Enhanced Approximation for RBIR PHY Abstraction in TGM

IEEE 802.16 Presentation Submission

IEEE C80216m-08/067

To modify the 802.16m EVM document related with Approximation part for RBIR PHY Abstractions

Accuracy of J approximation

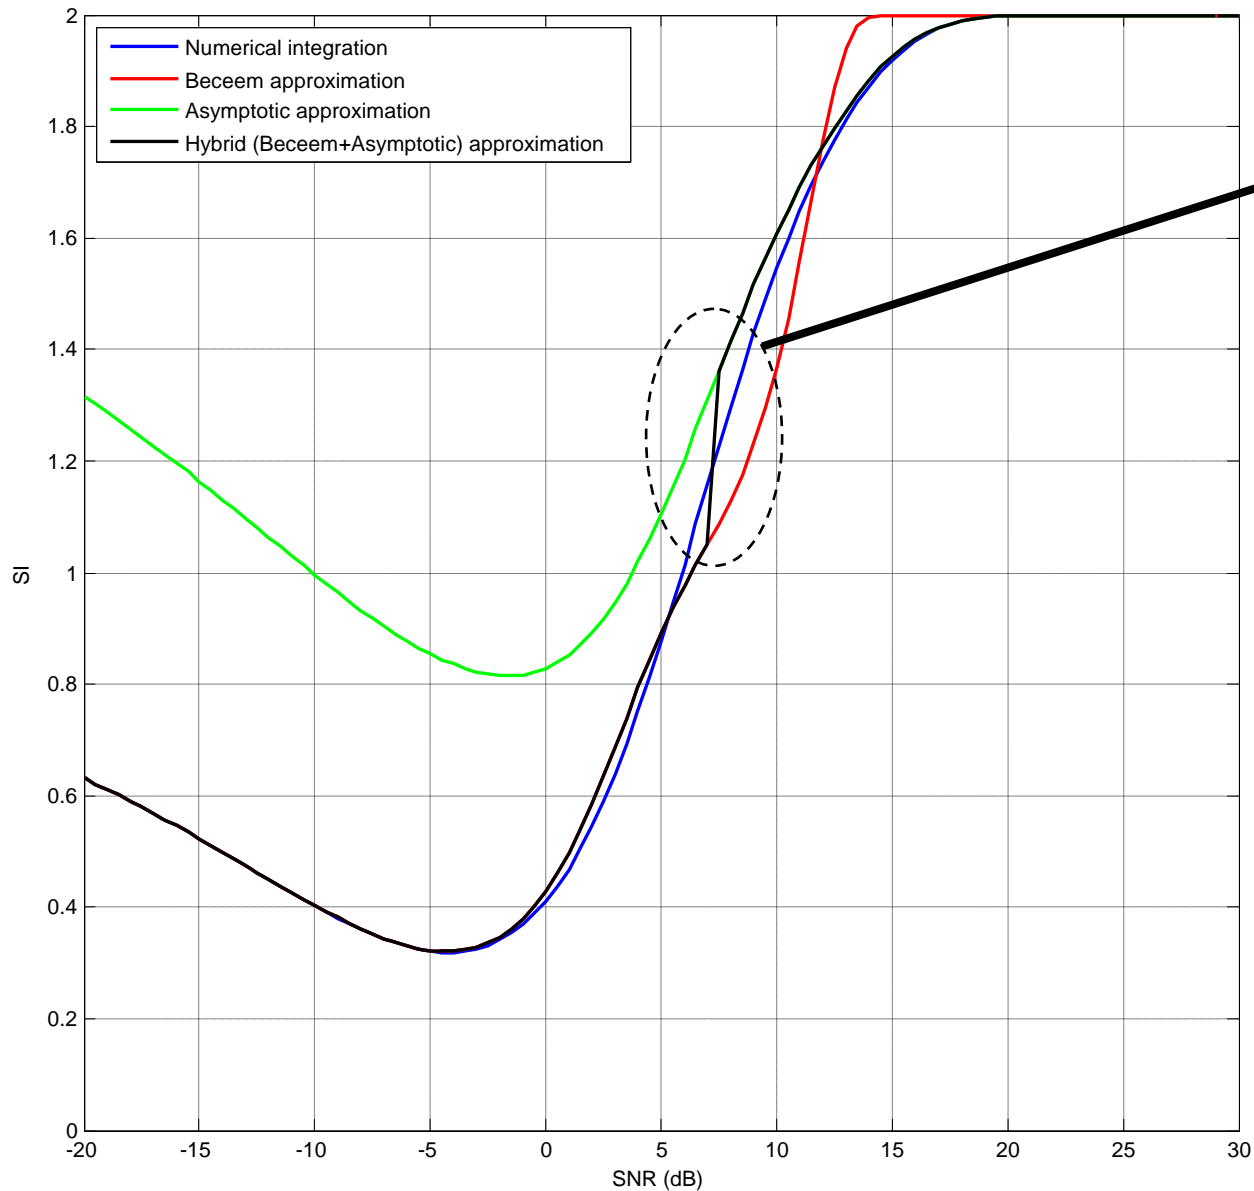
**Switching point
($J \approx 0.65$)**

**Perfect matching
of hybrid scheme**

Accuracy of SI approximation

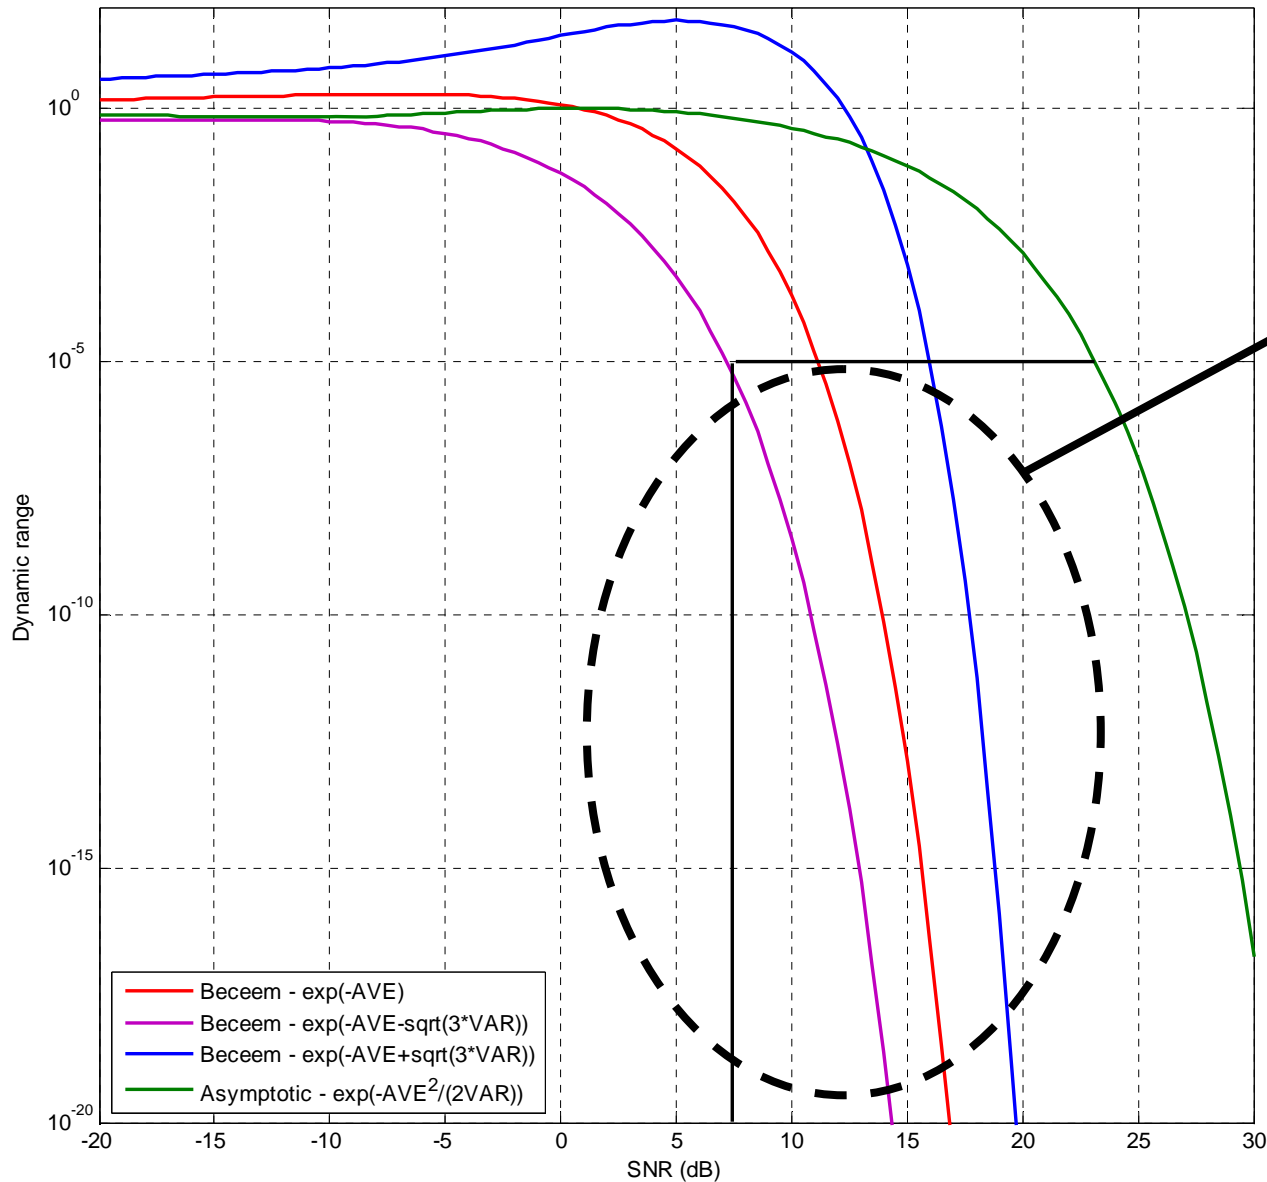
**Switching point
($J \approx 0.65$)**

**Perfect matching
of hybrid scheme**
